GOVERNMENT OF THE DISTRICT OF COLUMBIA
DEPARTMENT OF TRANSPORTATION

MEMORANDUM

SUBJECT: BZA Case No. 18994 – 254 15th Street, S.E. (Square 1073, Lot 22)
(Supplemental Report)

Figure 3
On-Street Parking Inventory - Road Segments

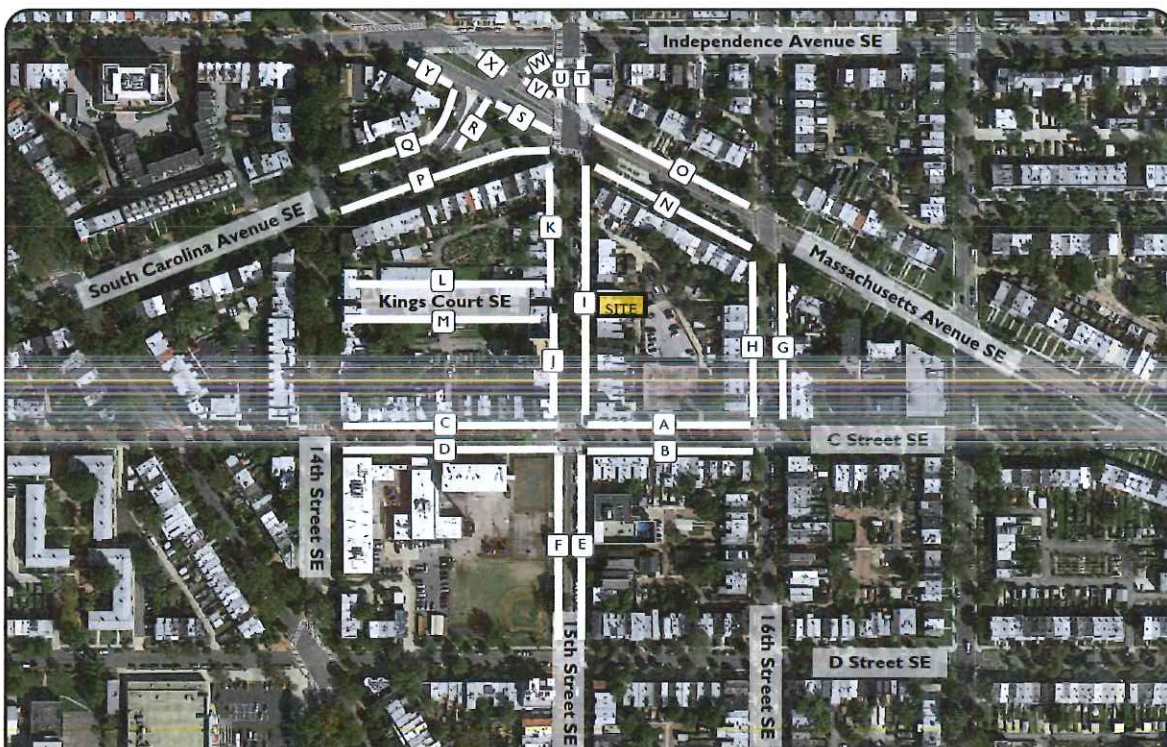
On-street parking utilization within the study area was at 75% of the existing on-street parking spaces occupied between 11:00 pm and 12:00 am, the peak-period for on-street parking utilization during the study period conducted on June 2, 2015. Given the available on-street parking, along with the proposed TDM measures, DDOT supports the lack of parking provision at this location.
